Technical Service Bulletin #0907

Upgraded Fan Motor Assembly Available On GU32 – 05/04/09

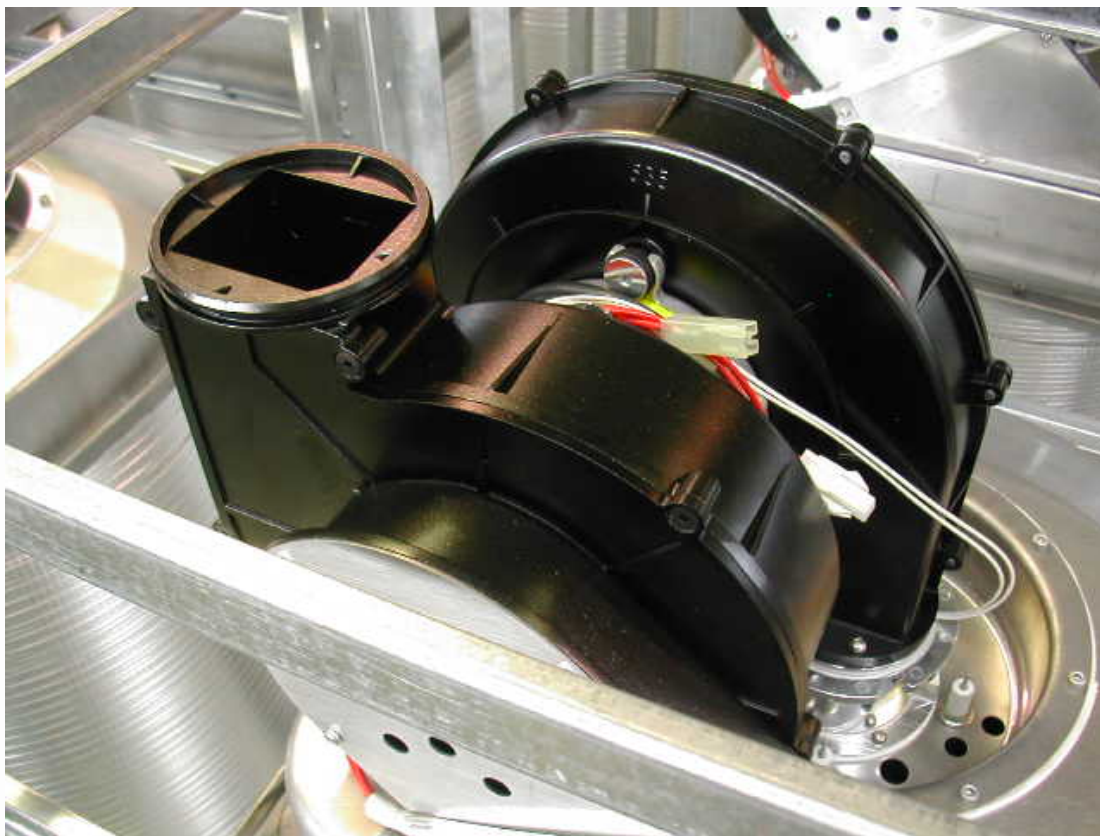
Newly built GU32s and GU28s are now equipped with an upgraded fan motor housing. The new housing is entirely cast of aluminum for better strength, quieter operation and improved reliability.

The new aluminum fan motor assembly is NOT backwards compatible with earlier units. When ordering replacement warranty part, please use the following part number and description:

302070299 – Dual Blower 32U Assembly (Aluminum)
